Product Change Notification / CAAN-20EDKO108

CCB 6045 Initial Notice: Qualification of MMT as a new assembly site for selected AT28C010x and AT28LV010 device families available in 32L PLCC (11.5x14x3.37mm) package.

CCB 6045
Pre and Post Change Summary
PCN #: CAAN-20EDKO108

Pre change

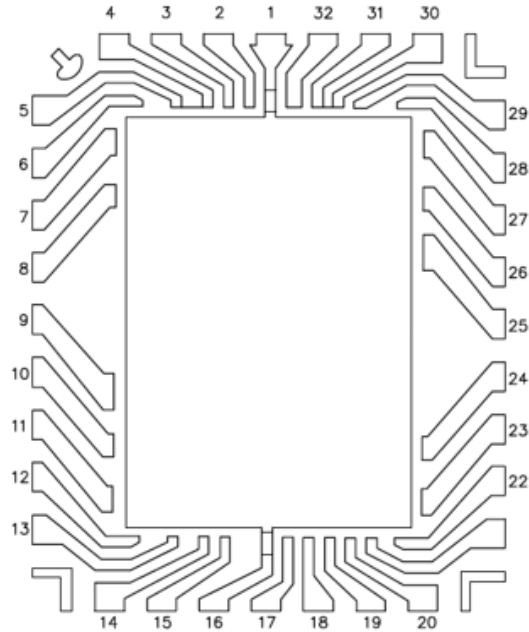
Lead frame DAP surface prep	Ag Spot Plated
Lead Plating	Matte Tin
Lead-Frame Paddle Size	391x275 mils

Post change

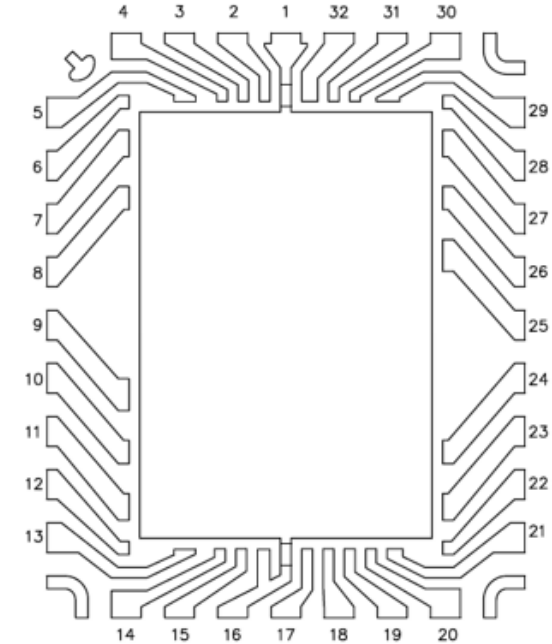
Lead frame DAP surface prep	Ag Ring Plated
Lead Plating	Matte tin
Lead-Frame Paddle Size	401x275 mils

Pre change

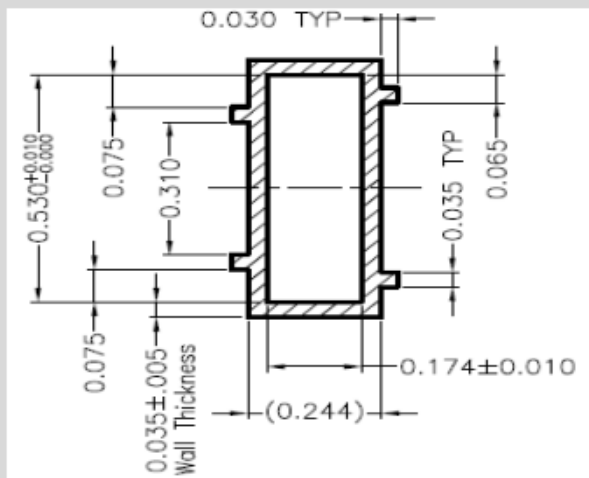
Length: 20.40 \pm 0.10 inch

Width: 0.600 \pm 0.015/-0.005 inch

Tube Opening Length (A): 0.174 + 0.010 inch

Tube Opening Width (B): 0.530 \pm 0.010/-0.000 inch

Wall thickness (T): 0.035 + 0.005

Post change

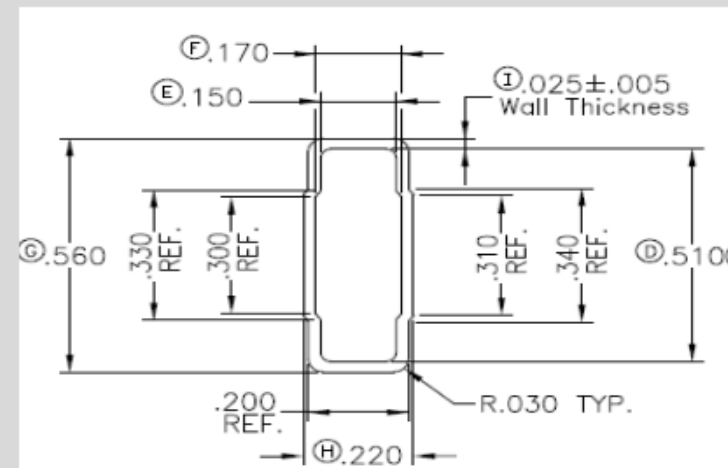
Length: 21.70 \pm 0.045 inch

Width: 0.560 \pm 0.015 inch

Tube Opening Length (A): 0.170 \pm 0.010 inch

Tube Opening Width (B): 0.510 \pm 0.010 inch

Wall thickness (T): 0.025 \pm 0.005 inch
